**DEFENSE NUCLEAR FACILITIES
SAFETY BOARD**

Staff Issue Report

February 18, 2016

SUBJECT: Waste Treatment and Immobilization Plant Quality Assurance Review

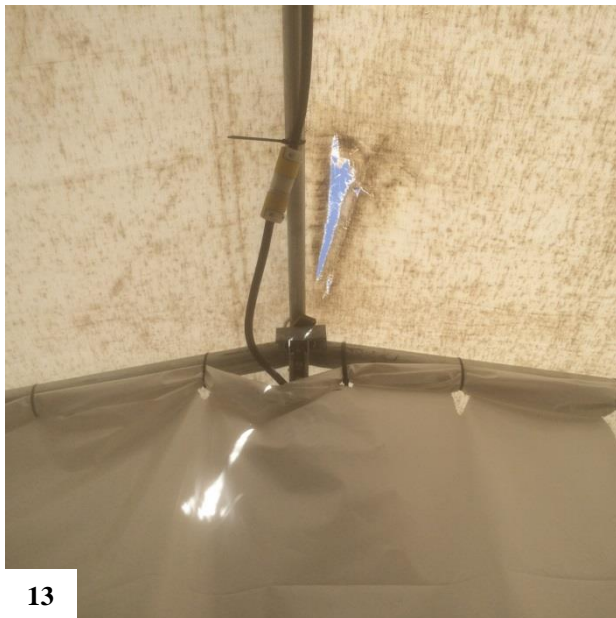
Deficiency 1, SSC Storage at the MHF Laydown Yard—In April 2015, at the MHF Laydown Yard, the staff photographed a substantial number of pipe spools and other SSCs buried in the sand and surrounded by excessive vegetation. Some SSCs were missing required protective coverings on their openings, and as a result, some SSCs showed signs of animal intrusion, contained standing water, or had a buildup of sand inside. See Appendix 1, Figures A-1 to A-8, for example photographs. These storage conditions are contrary to the following requirements:

Deficient storage conditions at the MHF Laydown Yard largely result from frequent high winds, blowing sand, and tumbleweeds, combined with inadequate corrective actions. BNI project procedure, *Field Material Inventory Management*, requires monthly surveillances of the MHF Laydown Yard. BNI assigned craft personnel to correct deficiencies identified during monthly surveillances; however, these efforts were not effective in maintaining compliant storage conditions. After receiving the staff review team’s agenda, BNI temporarily removed SSCs from rows 19 and 20, removed all sand, and leveled the ground. Appendix 1, Figures A-9 and A-10 illustrate BNI’s corrective actions. BNI also submitted a request for gravel to DOE-ORP. Pending approval, BNI expects the MHF Laydown Yard will be completely resurfaced with gravel within 2 years.

Figures A-9 and A-10. Photographs of the MHF Laydown Yard. Figure A-9 shows an aerial photograph of the 130 acre MHF Laydown Yard before Bechtel National, Incorporated (BNI) took corrective actions. Figure A-10 is a ground-level photograph of rows 19 and 20 following BNI corrective actions of temporarily removing all SSCs and removing the sand and leveling.

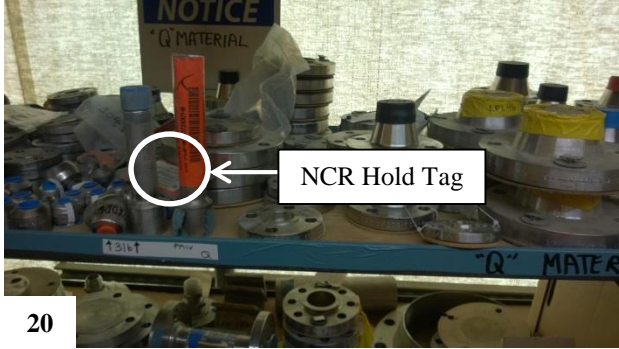
Deficiency 2, Storage Tents—In April 2015, , the staff photographed non-weathertight storage tents being used for “Level C Storage” at the MHF Laydown Yard and the WTP construction site. See Appendix 1, Figures A-11, A-12, and A-13, for example photographs. Some tents also showed evidence of animal intrusion. See Appendix 1, Figure A-14. These observed conditions are contrary to the following requirements:

- BNI project procedures, *RPP/WTP Storage Plan*, Section 2.3, and *Field Material Inventory Management*, Section 4.2, define Level C storage as “...a fire-resistant, tear-resistant, weather-tight, and well-ventilated building or equivalent enclosure.” In addition, BNI project procedure, *Material Control* [6], Section 5.8.1, requires material to be stored at appropriate storage levels.

Following receipt of the staff review team’s agenda, BNI performed an extent of condition for all Level C storage structures at the construction site. These structures included tents, small buildings, and trailers. BNI identified 10 structures requiring repairs and 8 structures that were less than adequate. BNI is relocating SSCs stored in deficient locations to warehouses. In addition, BNI will no longer designate storage tents located at the MHF Laydown Yard as Level C storage, unless they are repaired.
